## CRIME IMPACT STATEMENT

34 SANDY LANE, ROMILEY, STOKPORT  
EXTENSIONS & CHANGE OF USE TO FORM 22 no. BEDROOM HMO

VERSION B: 19/09/2023

REFERENCE: 2023/0045/CIS/01

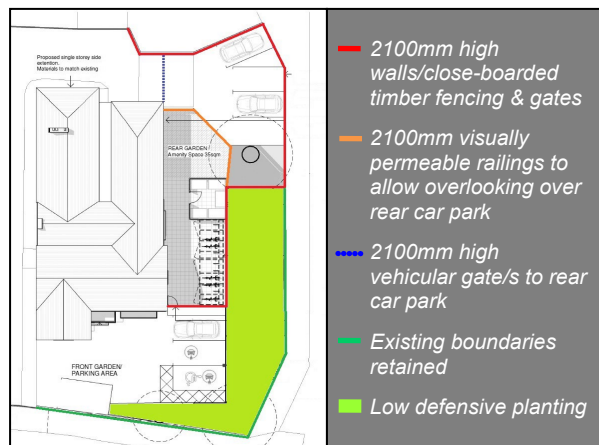
- 3.3.1 The garden area to the south side building (including the bin and cycle stores) should be enclosed with 2100mm high boundaries and lockable gates. Consideration should be given to a visually permeable boundary to the rear to allow residents to clearly overlook the rear parking bays (see illustration opposite and Section 4.4 for more information). The green area to the south of the garden, between the garden enclosure and the adjacent alleyway, should incorporate mature defensive planting to discourage loitering/gathering, damage and unauthorised access. Care should be taken to ensure that any existing or proposed trees do not inadvertently create climbing aids over boundaries to private space.

- 
- 3.3.2 The car park to the rear of the building must also be fully enclosed within a 2100mm high enclosure to prevent unauthorised access from the adjacent insecure garden space/alleyway, which offenders should utilise to attack parked vehicles and escape without being noticed. Consideration should also be given to the installation of a 2100mm high vehicular gate to prevent unauthorised access to the hidden rear parking area from the access route/adjacent garage colony (see illustration above and Section 4.4 for more information). All parking areas should be adequately and uniformly lit (see Section 4.5).

- 3.3.3 Ideally, the vegetation along the street frontage of the site should be thinned/lowered to maximise surveillance opportunities and ensure all parked vehicles, the main entrance and all residents/visitors coming to and from it can be clearly seen from the street.

- 3.3.4 The main communal entrance serving the building should security-certified, self-closing/locking and fitted with secure access controls to allow residents to control access (see Section 4.1). In addition to a robust access control system for visitors, there should also be a secure system for the delivery of post that ensures access to the building is not required (again, see Section 4.1 for more information). The proposed communal door to the rear of the building should be for the use of residents only.
